Product hierarchy no. *				Part no.	SBU	Type / Description	Customer part no.
SBU	PG	PGU	Type				
02	005	016	0000001169	See list below	Power Entry Moduls w/o Filters	DD11 Power Entry Module	n.a.

2 Type of change

Product Change Notification					PCN DD11		
owner	creation date	release date	released by	change order no	rev	page	D10-018-515
bachmajo	18.09.2017	18.09.2017	buerglal	2013731	A	1 of 2

Old label without configuration code	New label with configuration code

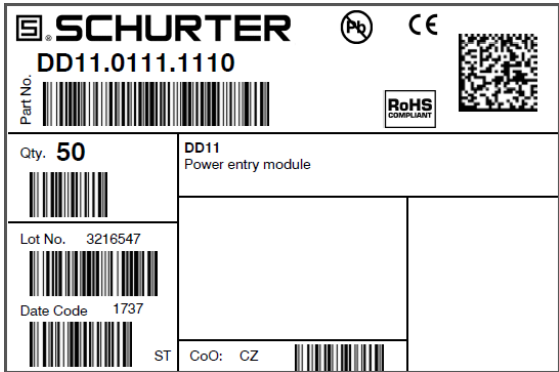
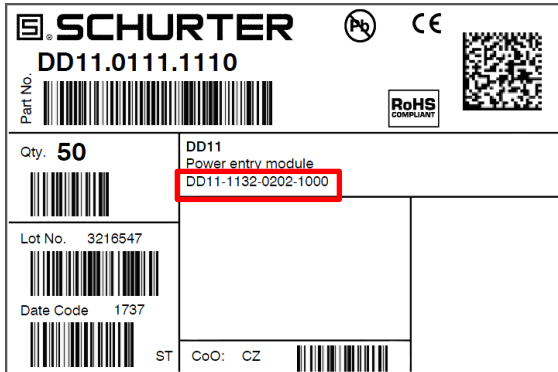
Change of plastic material from PET to PA6 (Socket)
Change of plastic material from PA6 to PA66/6 (Cover)
Inclusion of configuration code on label
